TETON COUNTY FAIRGROUNDS ARENA

ADDENDUM #3

(Construction Documents Revisions 1 and RFI Log)

Phase 1 - Indoor Arena Shell

A301
 Building Sections

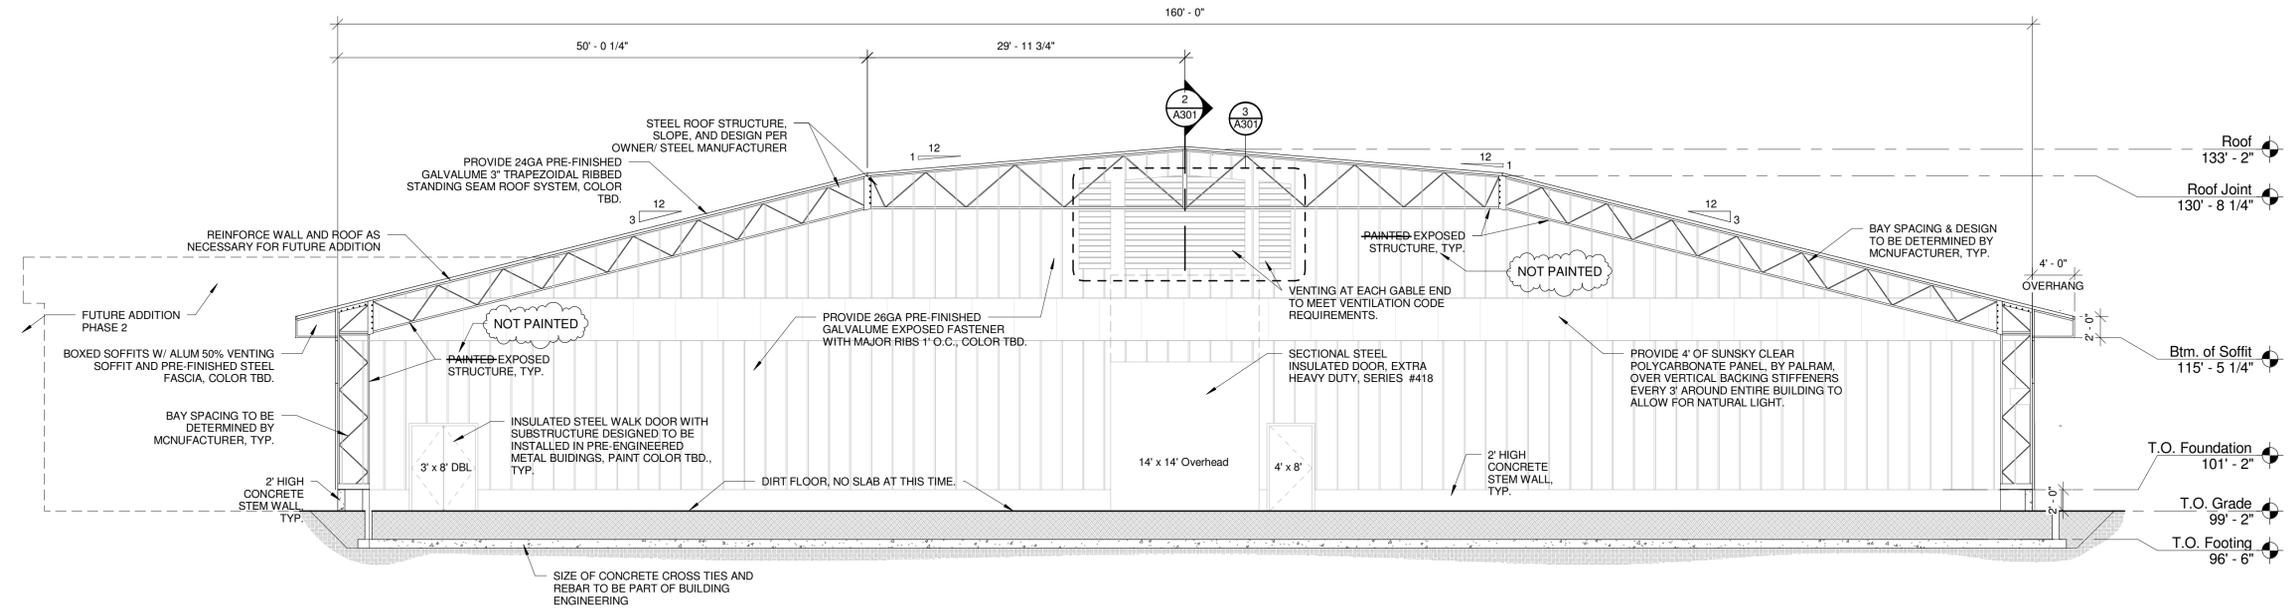
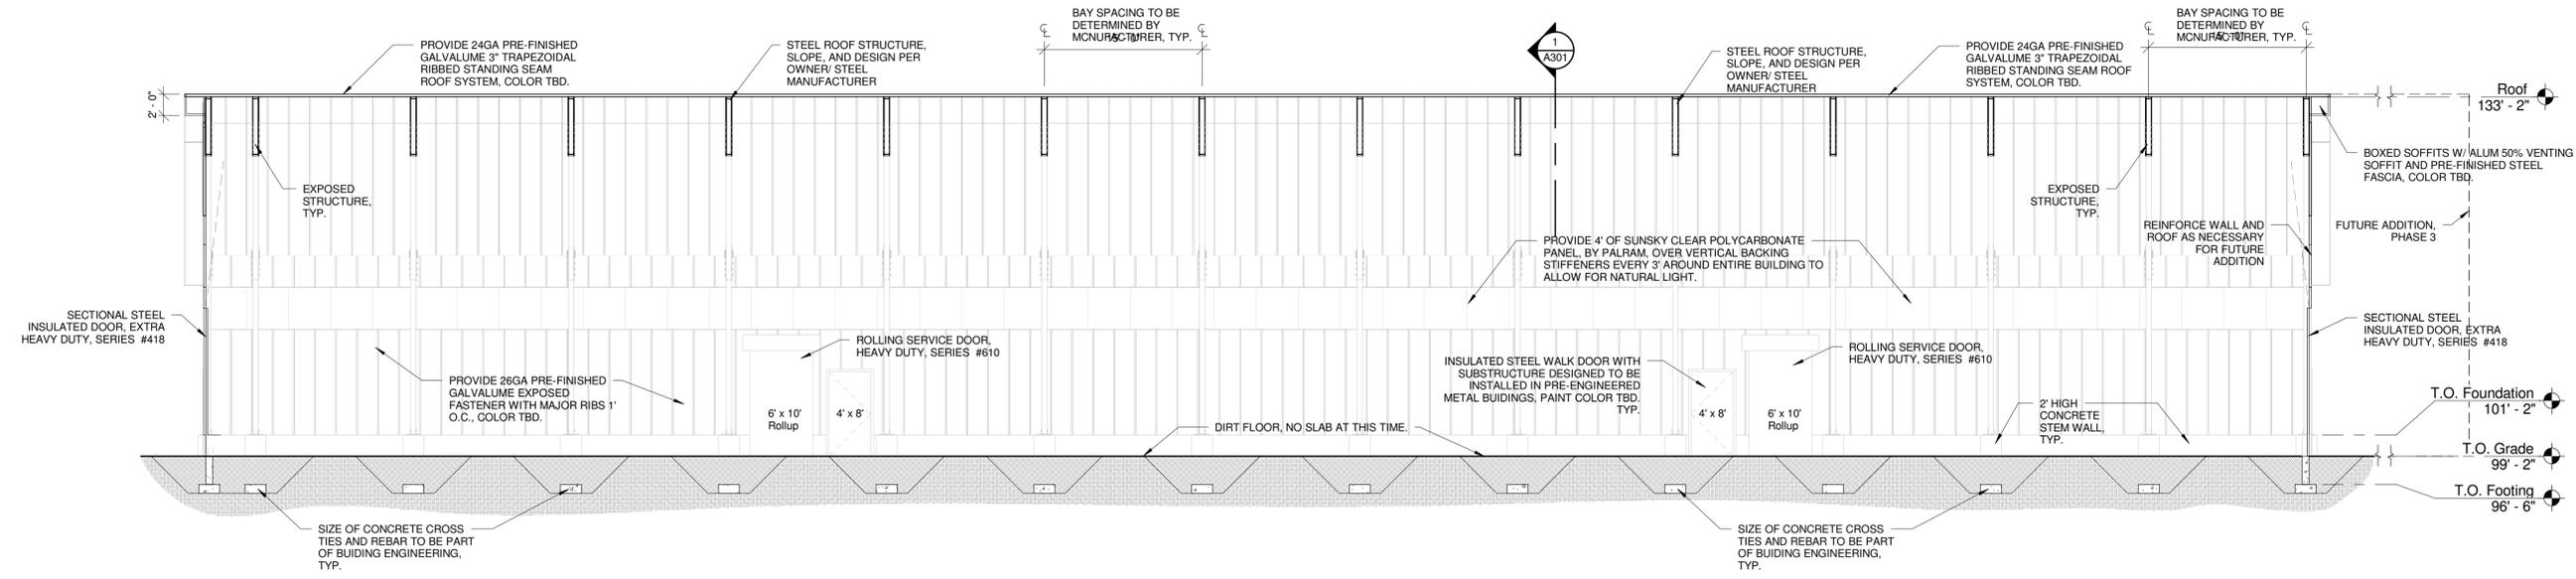
- A002 General Notes – Revised to be more project specific.
- A003 Site Plan – Noted to exclude all site work beyond arena shell from this Bid.
- A301 – Reference to “Painted” Steel Structure Removed

QUESTION: On Sheet A301 you call out painting the structure but there is no spec section for painting nor is there a line item under any of the alternates for painting, please clarify.

ANSWER: Painting of the interior steel structure will not be included in this Bid.

3 Louver Detail
 SCALE: 1/4" = 1'-0"

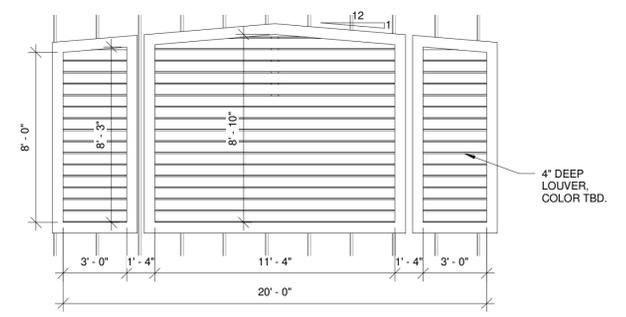
QUESTION: What is the material thickness of the louvers found on the gable ends for ventilation?

QUESTION: With the gable end vent louvers 8’ above the large overhead doors, how should we attach the necessary springs and rails to operate the door?

ANSWER: This thickness may vary between the various steel manufactures bidding the project, but we do know of one supplier that has a louver specified that has a material thickness of .081”

ANSWER: Because of the louvers, it will not be possible to slide the door vertically all the way up the wall. To help increase the headroom in front of these doors yet stay away from the louvers, please plan on installing the door track hardware up the wall vertically to just below the louvers then out horizontally into the arena space. We will have to suspend part of this door track approximately 8’ from the steel framing above.

1 Site Plan
 SCALE: 1" = 30'-0"

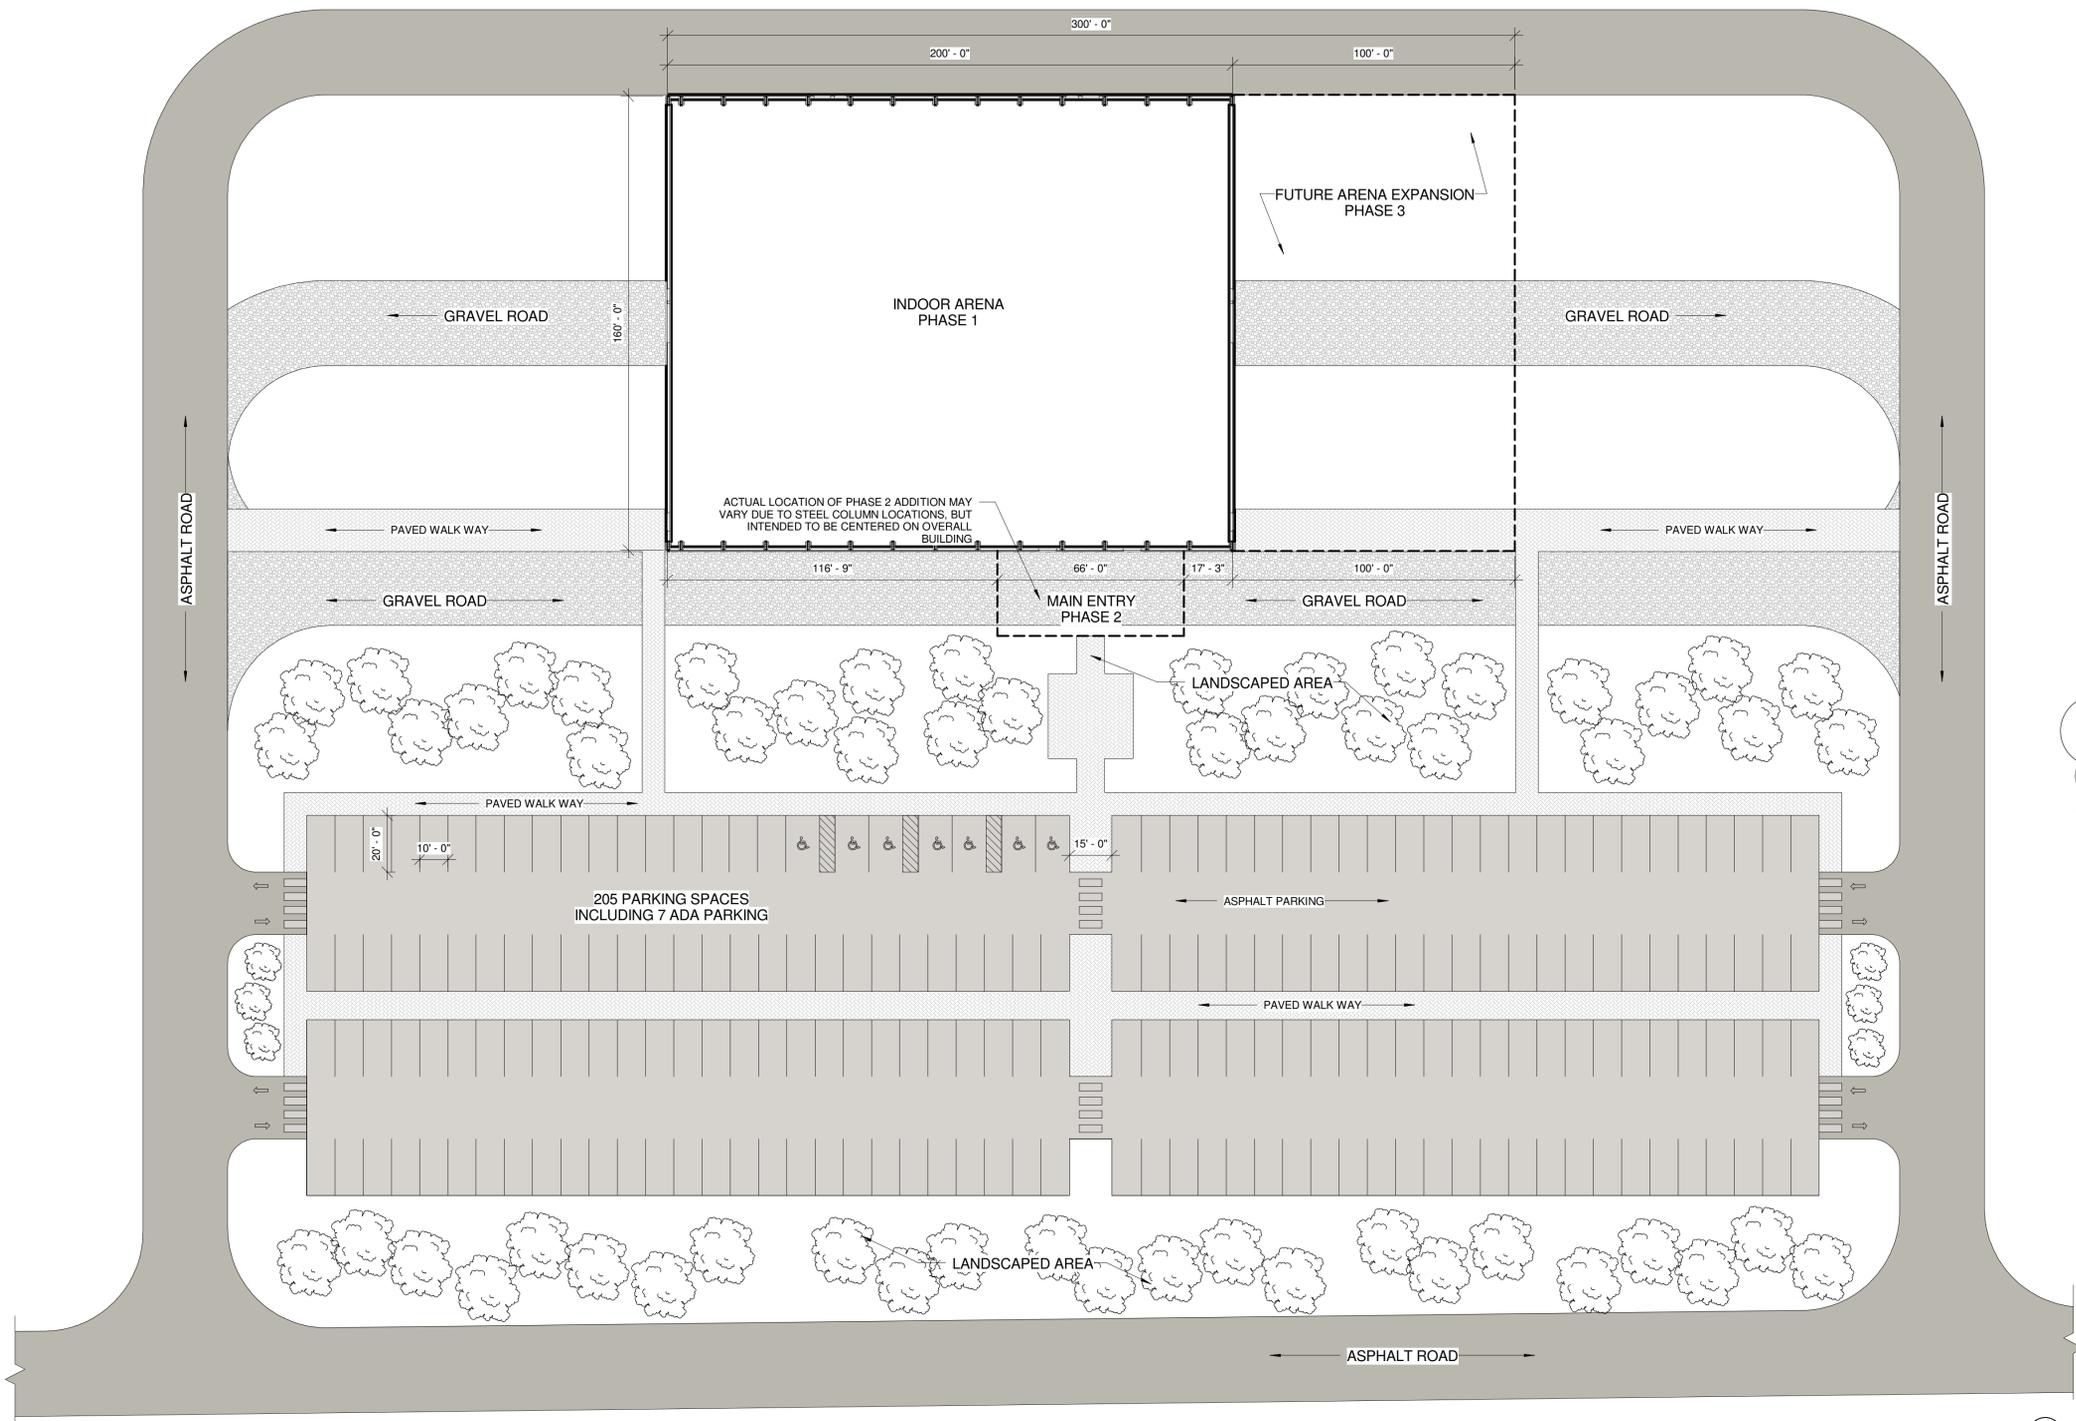
QUESTION: Sheet A003 shows parking, landscaping, please denote that this is in future work and not to be included in this bid.

Note:
 All sitework beyond arena shell are not included in this Bid and will fall under a separate contract at a later date.

ANSWER: All site work outside the scope of the Arena shell is not included in this Bid and will fall under a separate contract with Owner at a later date.
